ADDENDUM NO. 2

Rochester City School District

Dr. Walter Cooper, School #10

February 28th, 2018

C1607

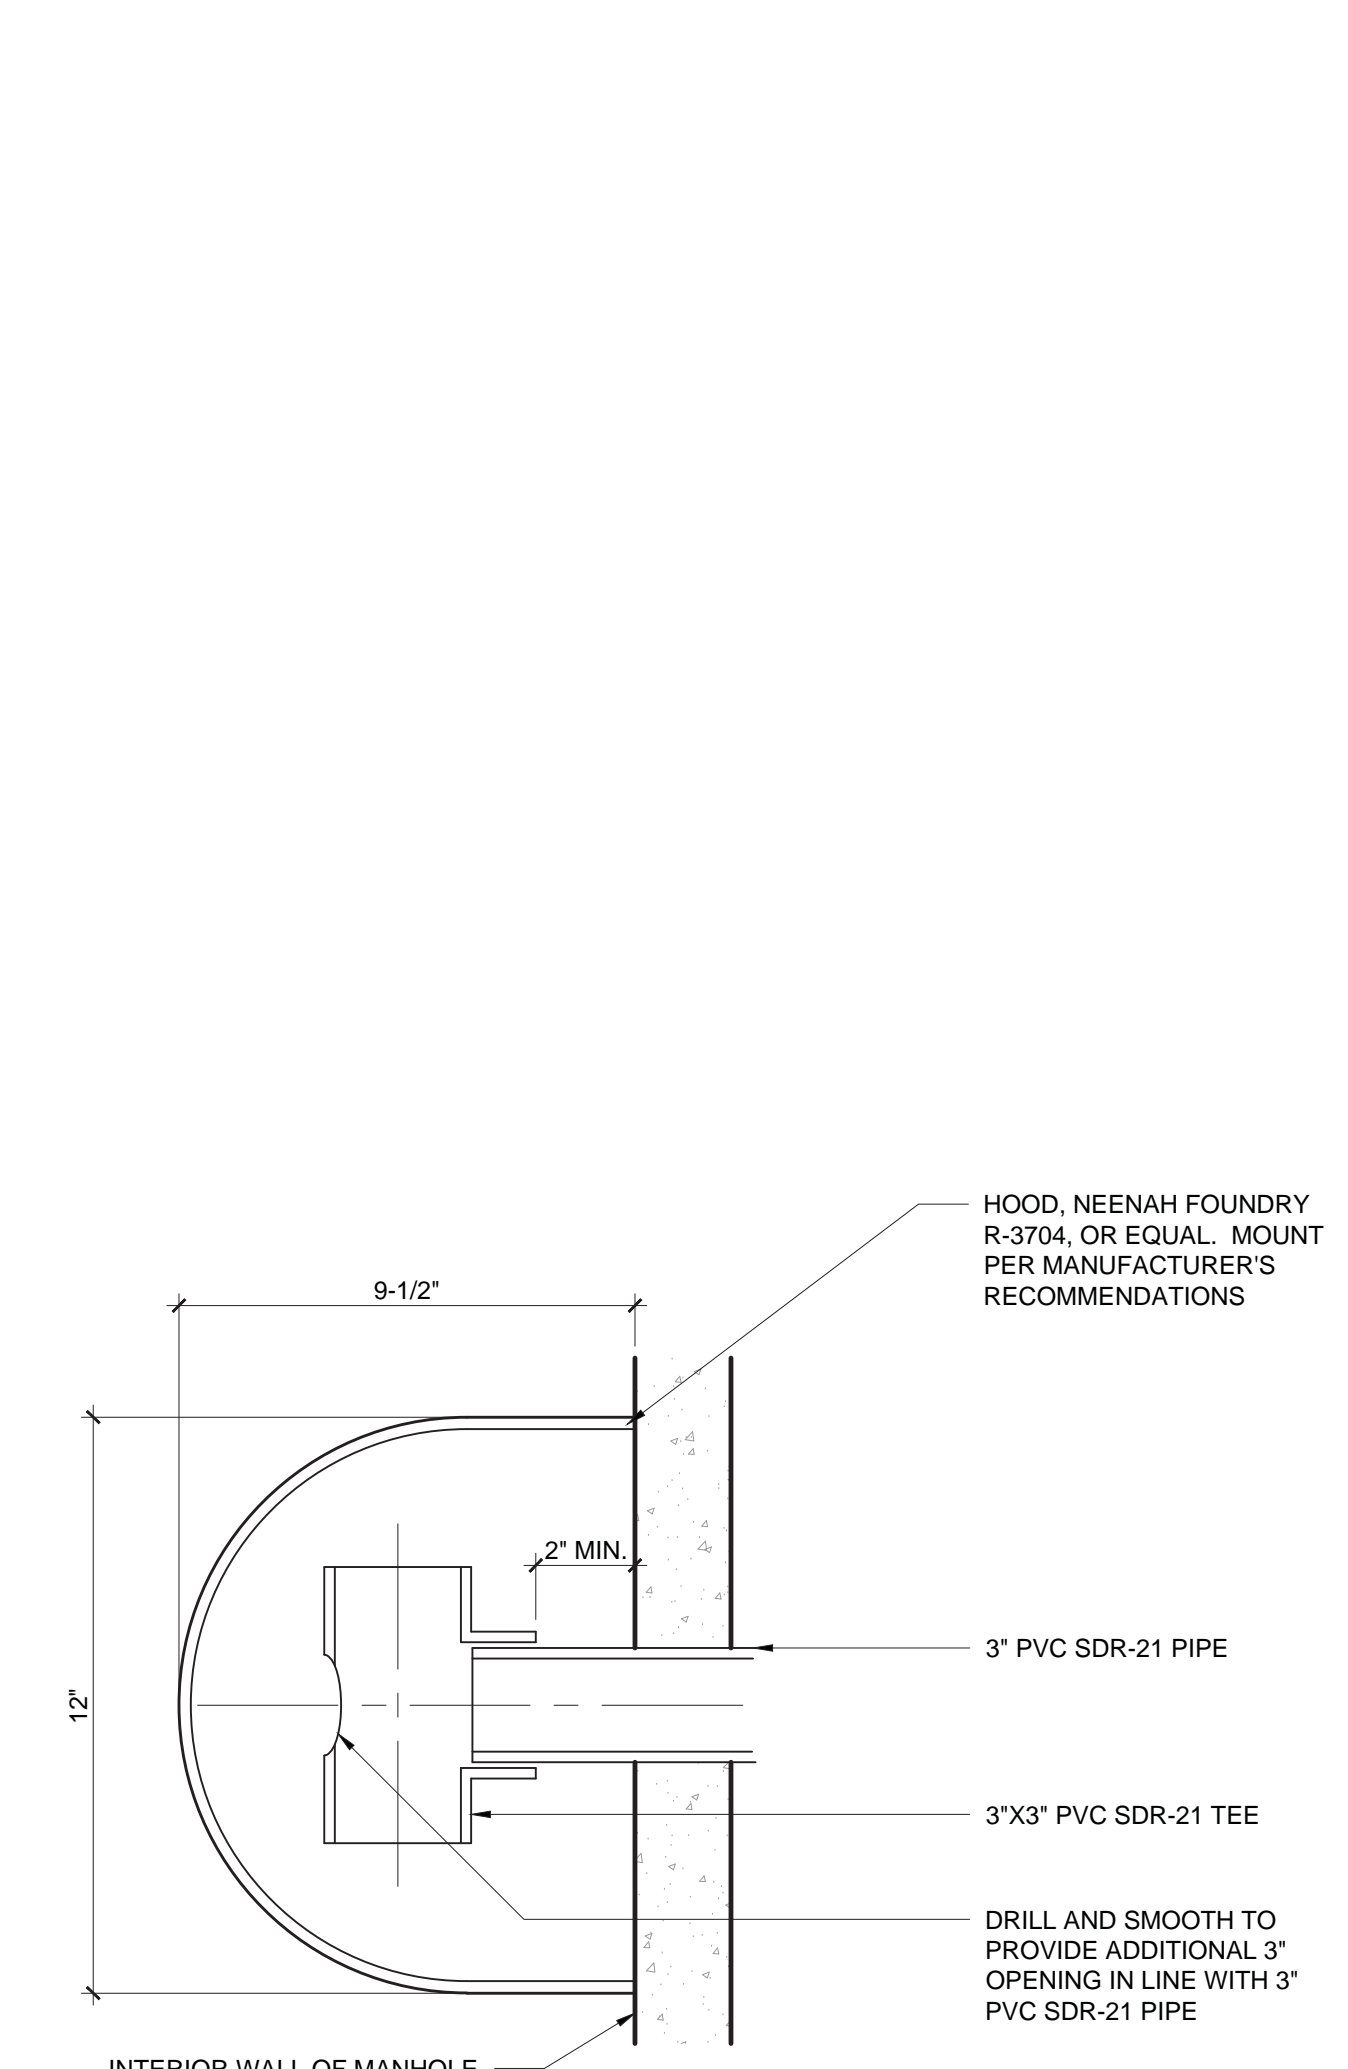
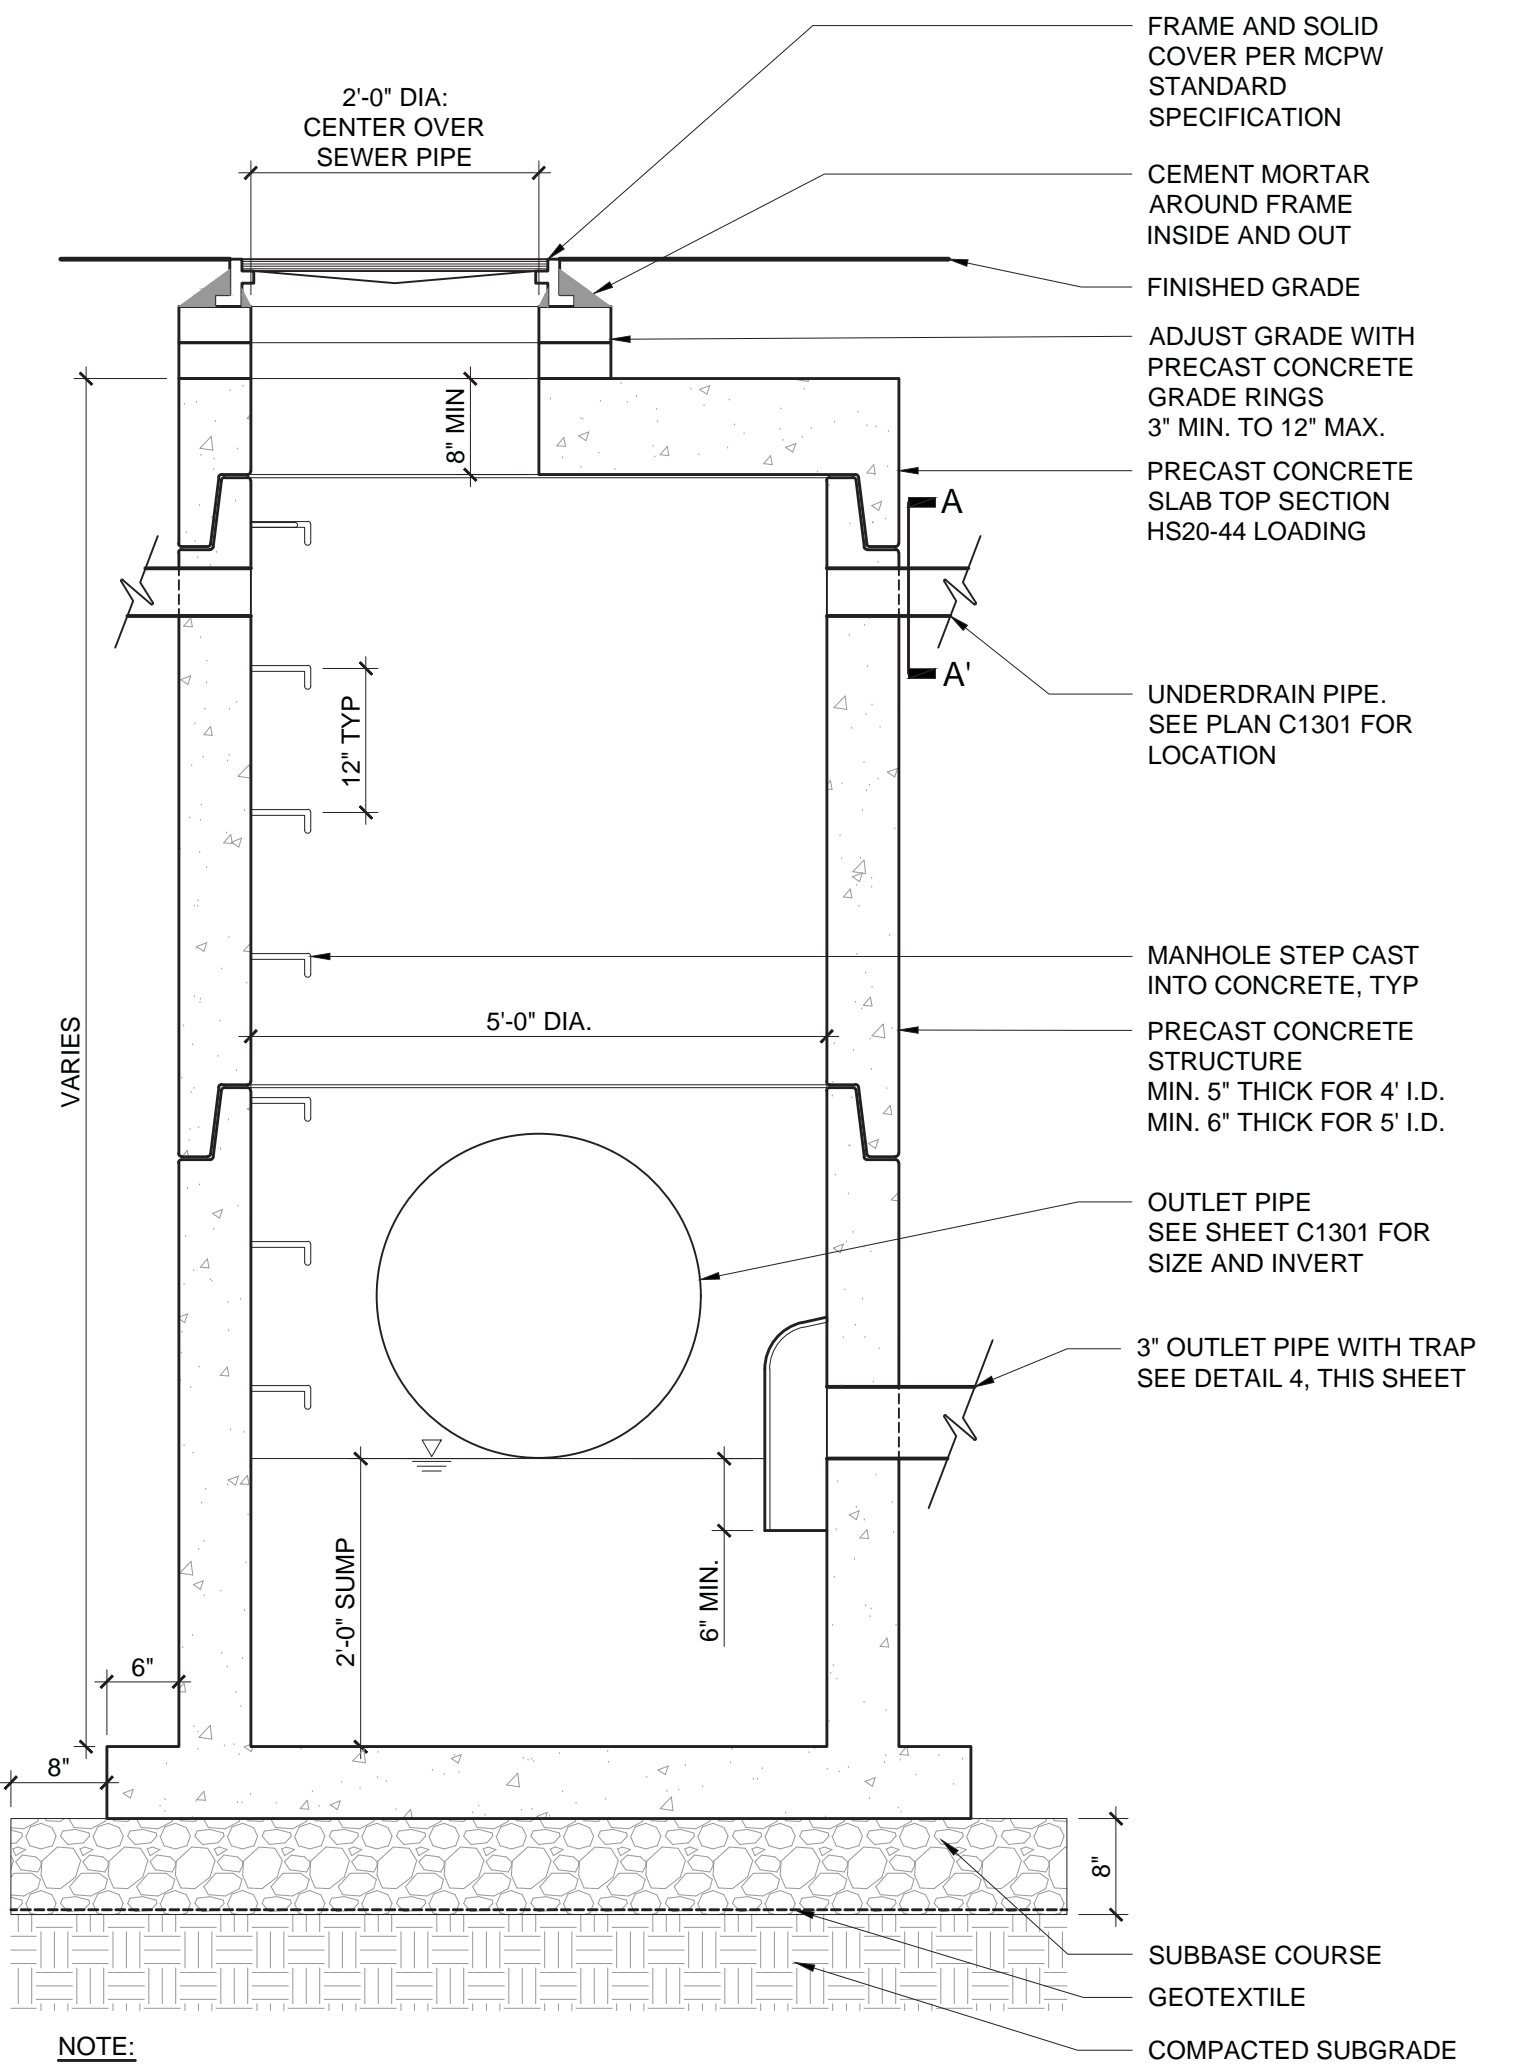
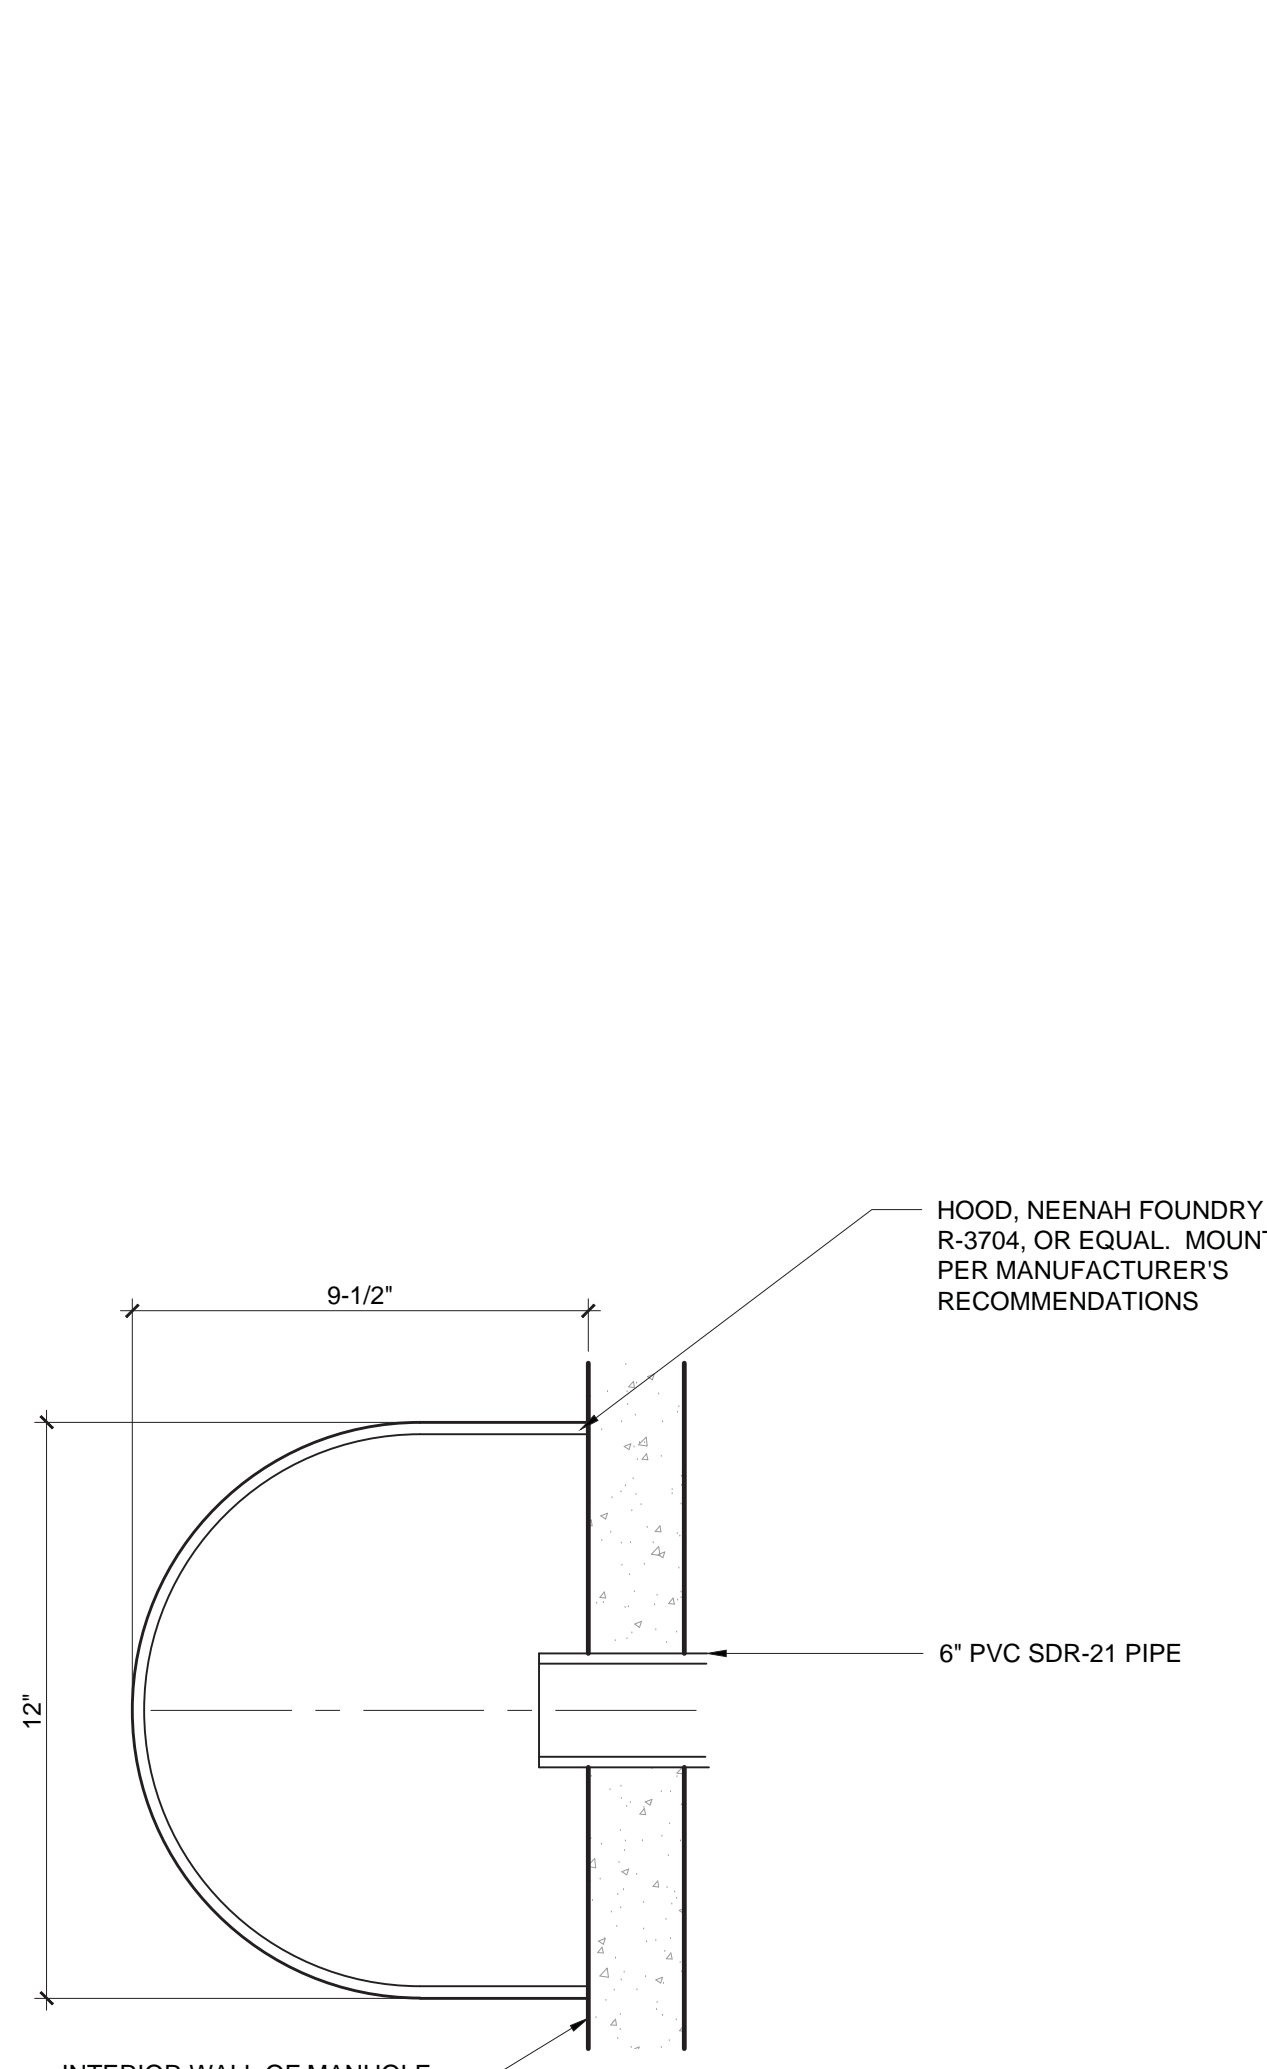
Item AD2-15 **REPLACE** drawing in its entirety with attached “C1607 – DETAILS.” Add Monroe County Pure Waters required details.
